Date: June 23, 2021
To: All Vendors
Subject: Addendum #1

REFERENCE: B 062-21 Southmost 2.0 MG Elevated Storage Tank

Addendum No. 1
B062-21 Southmost 2.0 MG Elevated Storage Tank
Brownsville PUB

ADDENDUM NO. 1
SOUTHMOST 2.0 MG ELEVATED STORAGE TANK

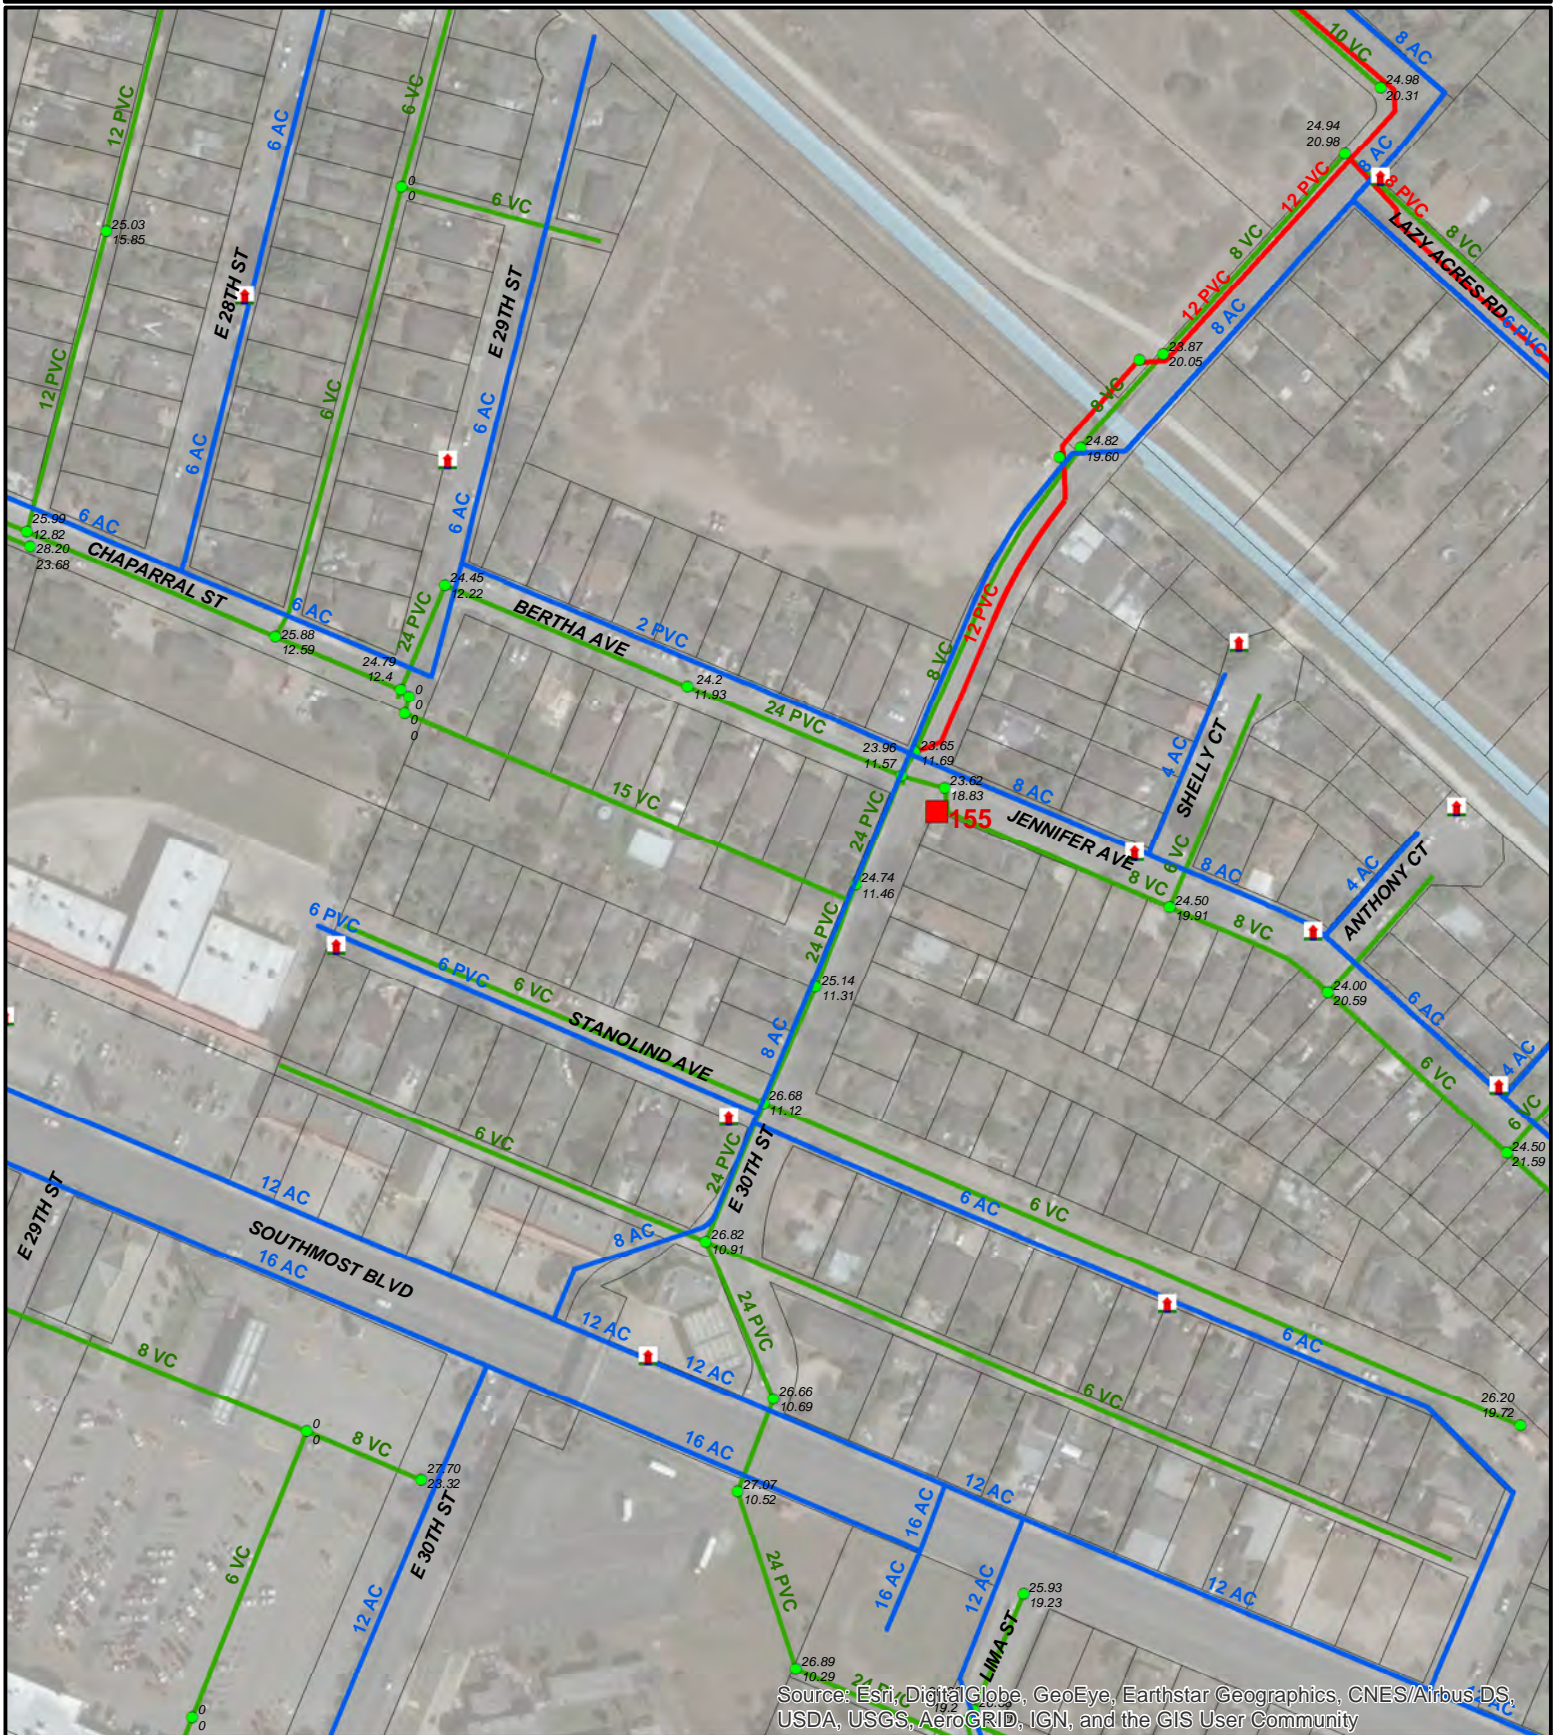
Q26: Drawing T-7, CLF Details seem to show a concrete mow strip under the fence. Is one required? If so, please provide a detail (width, thickness, reinforcement)

A26: The concrete mow strip will be 6"x6". See updated sheet attached.

ELEVATED STORAGE TANK PLAN

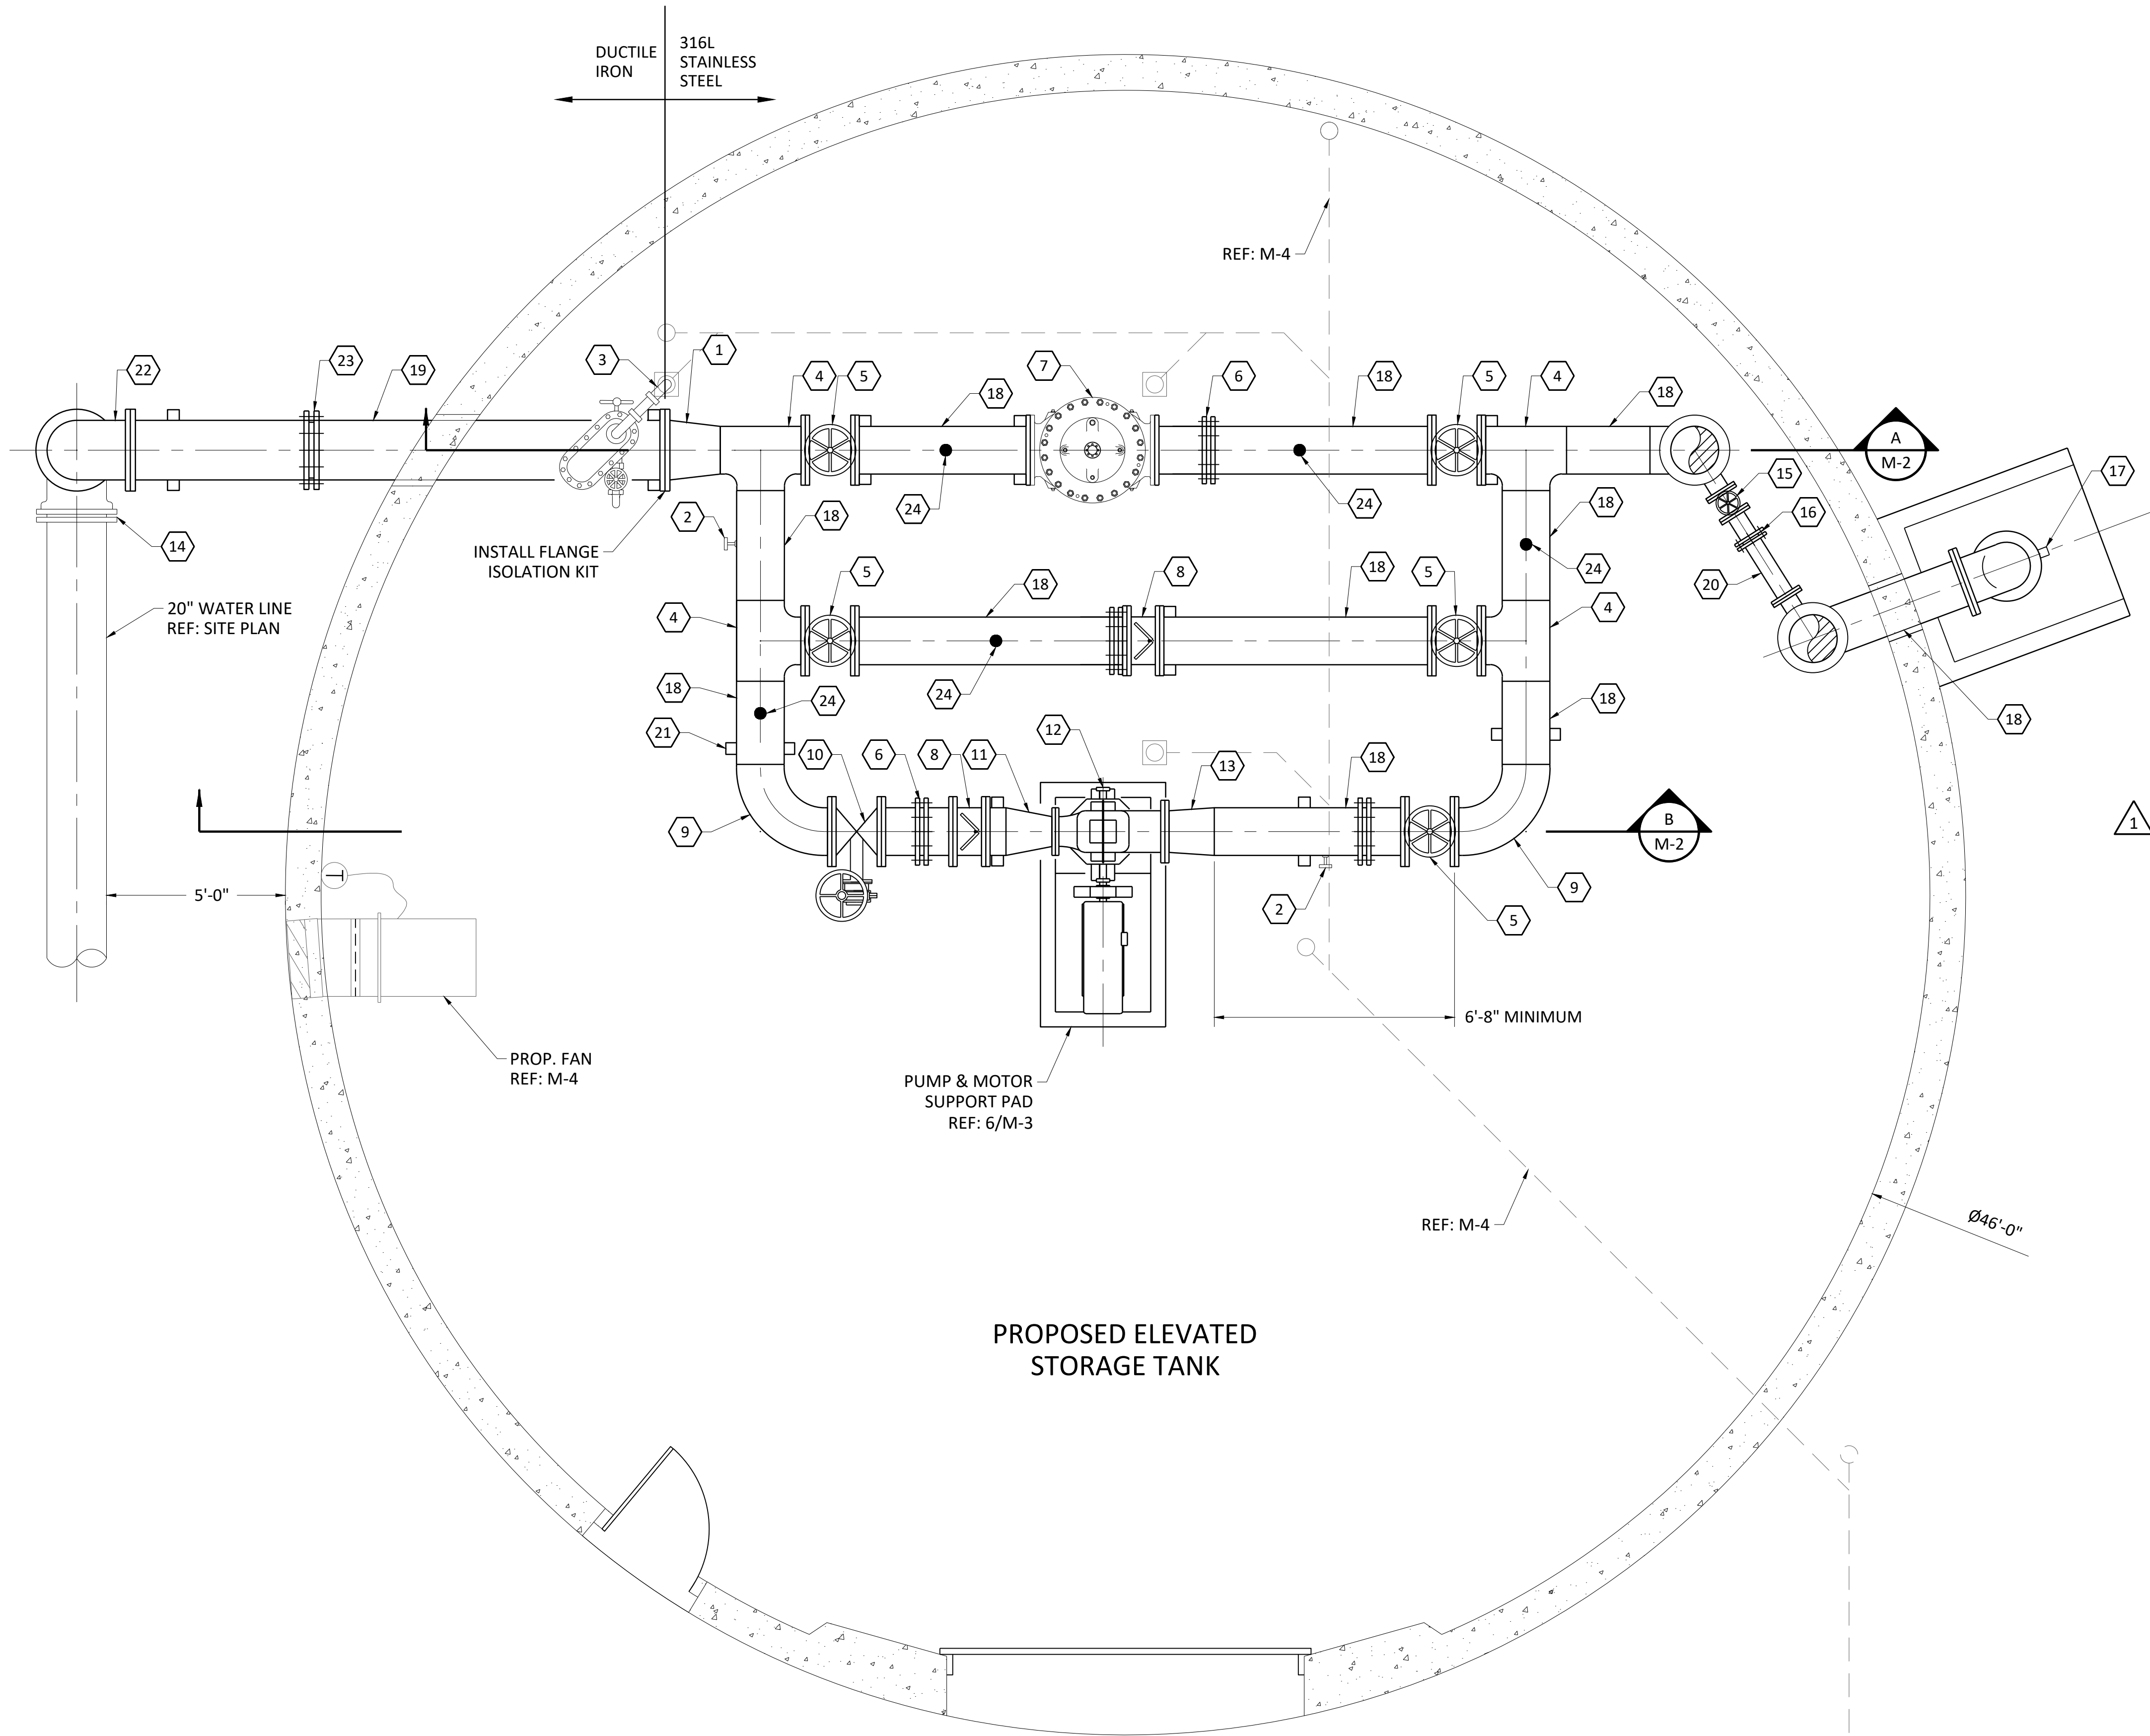
- f. Drawing "Elevated Storage Tank Plan" Sheet M-1 is replaced with "Elevated Storage Tank Plan" Sheet M-1 shown in the attachment provided by Freese and Nichols, Inc.

Q30: Drawing M-1 General Note 4. Typically, the interior of the ductile iron pipe is factory cement lined and shipped with an exterior prime coat, with the exterior paint system field applied to the exterior only. Please confirm this is acceptable and no DIP interior field coatings are necessary.

Q22: Section 13210 Item 2.06.L specifies Type 316 stainless steel piping, as well as Drawing M-1. However, Drawing T-5 Mechanical Note 1 says piping is Type 304 stainless steel. Please clarify.

A22: Type 316 stainless steel piping is to be used.

A30: Please refer to revised Drawing M-1 issued with this addendum.

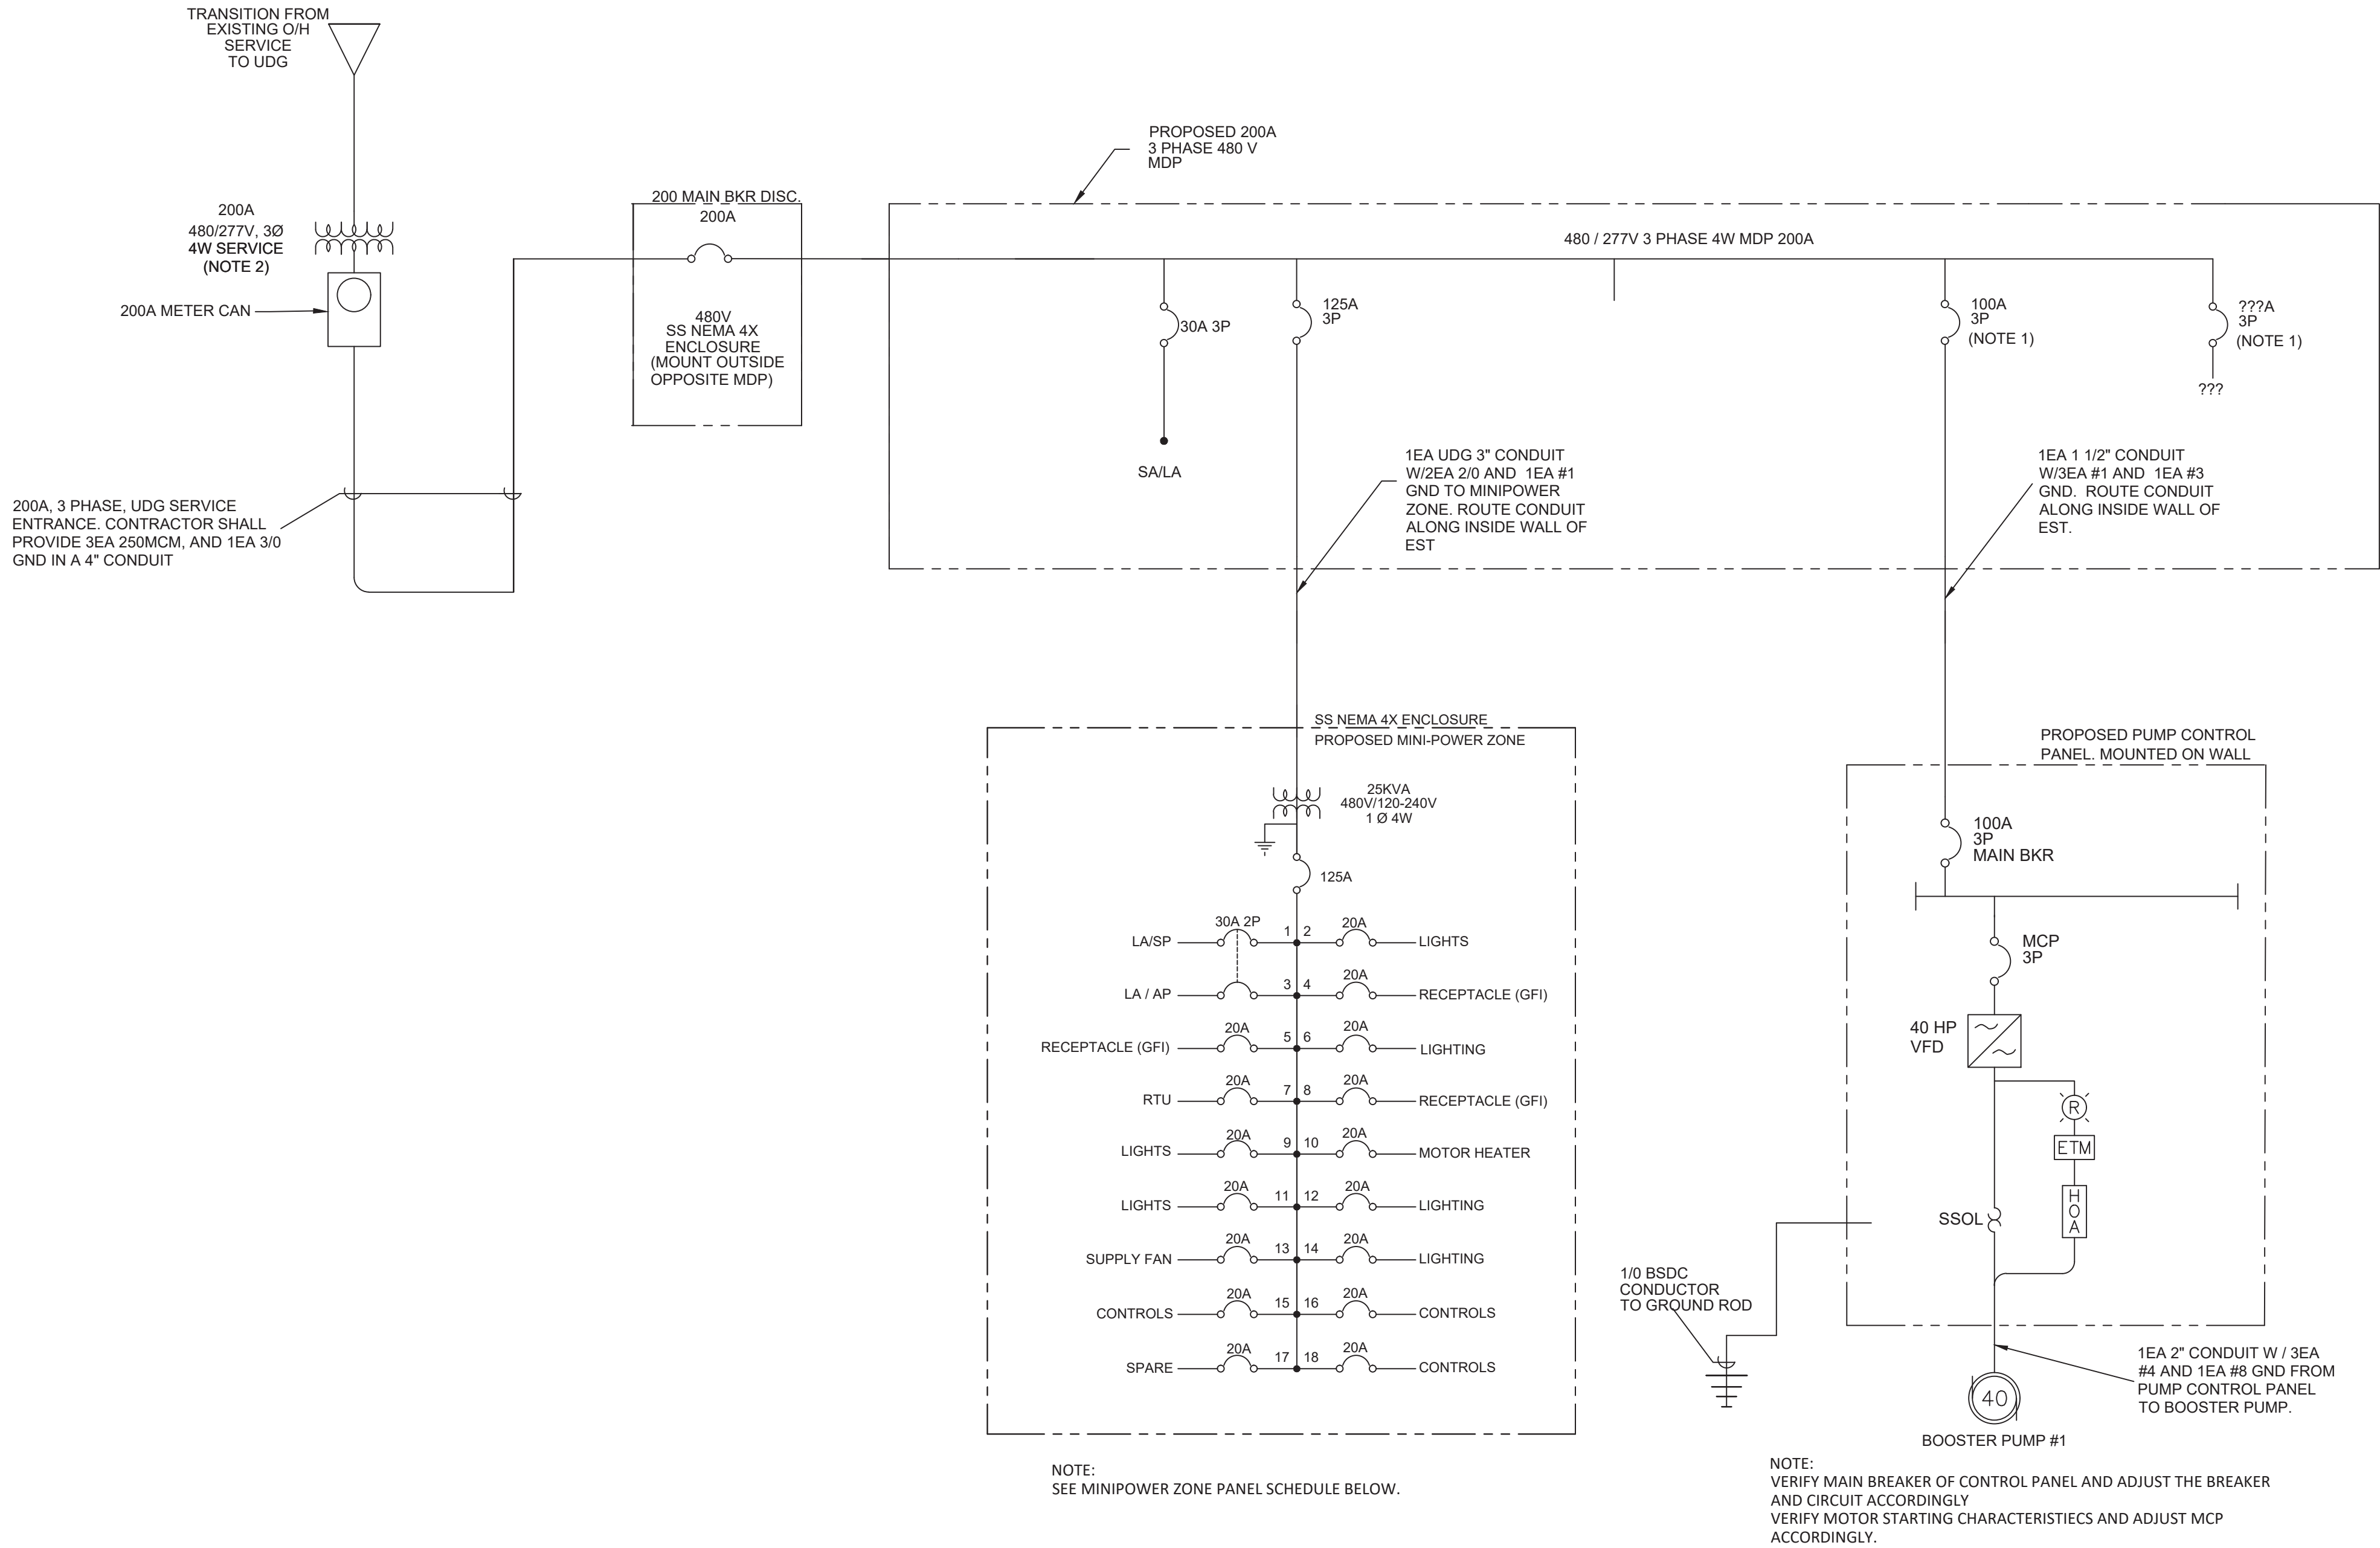
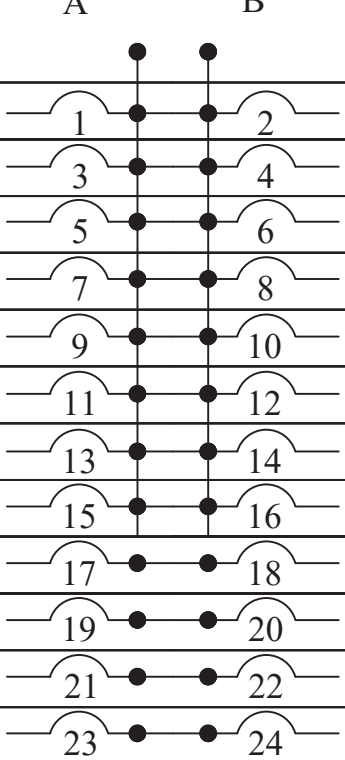
- g. Drawing "One Line Diagram and Panel Schedules" Sheet E2 is replaced with "One Line Diagram and Panel Schedules Addendum #1" Sheet E2 shown in the attachment provided by Square E Engineering.

- Drawing E2
 - o The Bidders shall remove all reference to Cathodic Protection. There will be no Cathodic Protection on this project.
 - o The Bidders shall remove all reference to a Sump Pump. There will be no Sump Pump on this project

- o The Bidders shall find these changes on drawing E2 submitted for Addendum #1 attached.
- Drawing E3
 - o The Bidders shall find the following changes on Drawing E3 submitted for Addendum #1 attached.
